## ***Interactive comment on “A critical assessment of simple recharge models: application to the UK Chalk” by A. M. Ireson and A. P. Butler***

**A. M. Ireson and A. P. Butler**

Received and published: 15 January 2013

**Fig. 1.** Illustrative relationship between unsaturated zone storage and recharge

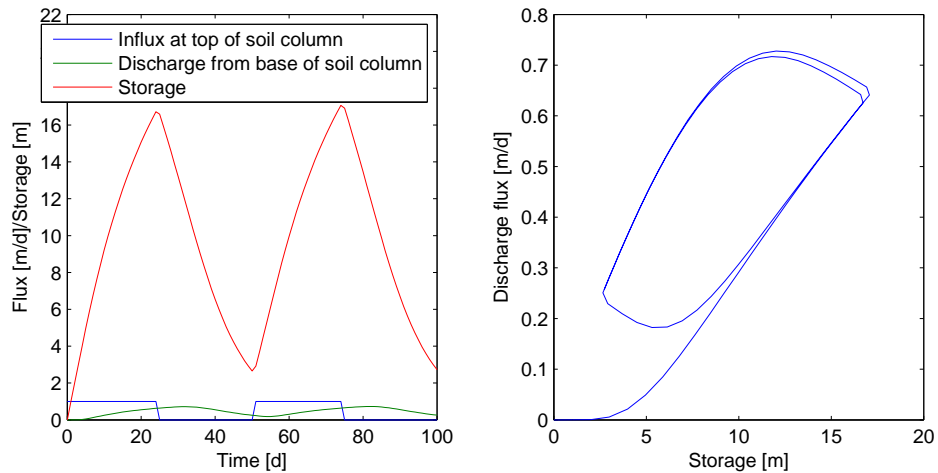
The second point relates to the reviewers comment “That there is no relationship between storage and flux is not reasonable and should be discussed carefully” and then later in the review “It is not quit [sic] reasonable that there is no relationship between recharge and unsaturated soil storage. [...] matrix recharge should have a correlation to storage.” These statements are incorrect. In Richards’ equation models, the flux is driven by a gradient in the state variable (i.e. Darcy’s law), not the magnitude

In response to the reviewers comment that it is “unreasonable” that there is not a relationship between the flux out of a soil column and the storage within that column, a simple numerical experiment is presented here. It should be easy to replicate this simulation using any Richards' equation solver (e.g. Hydrus 1D which is freely available). We have also included the MATLAB script which was used to solve this problem below (see supplementary zip file). We consider a 500 cm soil column, with van Genuchten parameters as follows:  $\theta_R=0$ ;  $\theta_S=0.35$ ;  $\alpha=0.1 \text{ cm}^{-1}$ ;  $n=1.4$ ;  $K_s=2 \text{ cm/d}$ ;  $n_e=0.5$ . At base of the soil column is a fixed water table. At the top, an infiltration flux alternates between 1 mm/d and 0 mm/d, switching every 25 days over a 100 day simulation. The simulation result is shown in the attached Figure. The discharge flux is clearly not uniquely related, linearly or non-linearly to the storage. In fact here it is cyclic, due to the periodic boundary conditions. This is a very simplified example, but it makes the point adequately. When evaporation processes are also operating, as in the model in the paper, there will be upward and downward fluxes in different parts of the unsaturated zone. It should then be clear that there is no reason to believe that there would be a relationship between storage and discharge from the base. This is perhaps a useful demonstration, because it shows clearly that Richards' equation models behave unlike linear or non-linear stores that are commonly used in hydrological models.

of the state. It does not necessarily follow that there should be a relationship, linear or otherwise, between the state and the flux. There often is no relationship, and this can be shown using a simple, Richards' equation model for a single porous medium. We provide an easily reproducible demonstration of this point in the Appendix in this response. For the particular case described in the paper, the system is much more complicated, with a deep unsaturated zone, fracture flow and significant evaporation processes (i.e. bi-directional vertical flow). Fig 5 showed clearly that there is no simple relationship between the recharge flux and the storage in the matrix, and we do not find this result unexpected or surprising. This is why finding a simple model that can reproduce the detailed model is extremely challenging. Whilst we have removed the detailed analysis of unsaturated zone storage versus recharge from the paper (section 3.1 and Figure 5 in the original manuscript), this is to improve the focus of the paper and not a concession that this analysis was flawed.
